72-1029

July 2, 2004
ANUH-01-04-05

Subject: Response to the Request for Additional Information (RAI) for Chapter A.4 and Submittal of Revision 2 of Application for Amendment No.1 of Advanced NUHOMS® Certificate of Compliance (CoC) No. 1029 for Dry Spent Fuel Storage Casks (TAC No. L23606)

Figure A.4.7-8
Maximum Fuel Cladding Temperature during Vacuum Drying Using Air for Blowdown

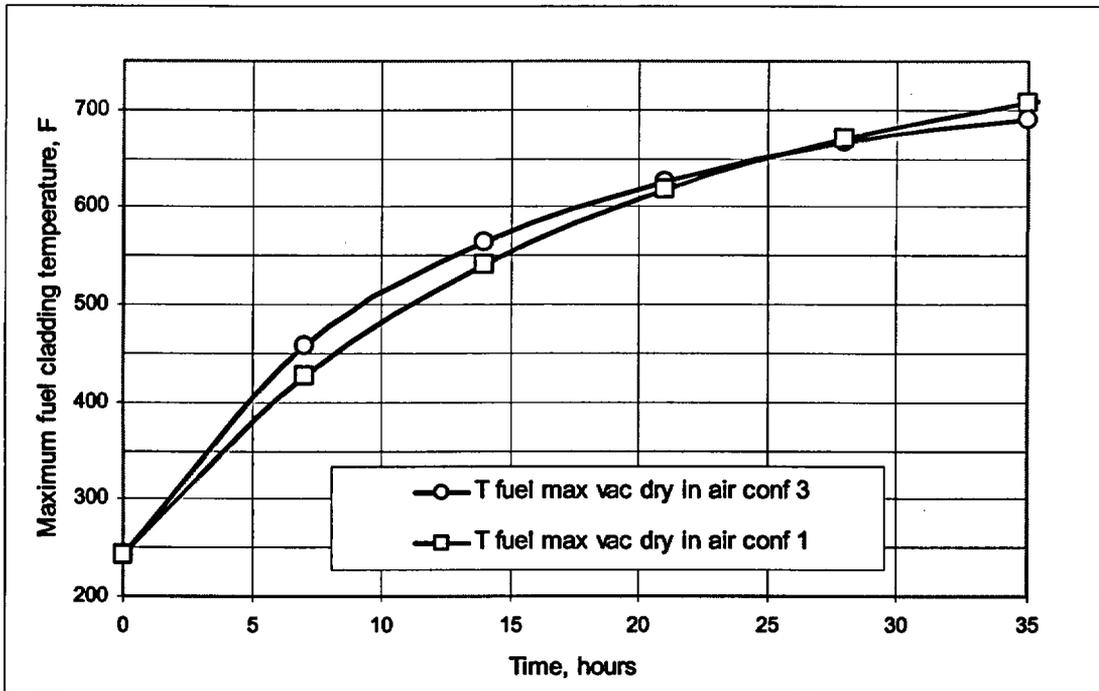
Evaluate the initial conditions for the canister heatup analysis presented in SAR Section A.4.7.3 and revise them as necessary. Update all related analyses for air and helium as appropriate (accounting for new initial conditions and the issues presented in Question 4-1) and submit the model details and results for staff review. Provide a graph of maximum fuel cladding temperature versus time for helium (similar to Figure A.4.7-2 for air) in addition to an updated graph for air.

Figure A.4.7-8 has been updated to reflect the conservative starting temperature of 230°F. The predicted helium steady state temperature demonstrates that no time limit is required for the helium blowdown configuration. This analysis has been generated using the DSC CFD analyses. The model details are included in SAR Section A.4.4.4.
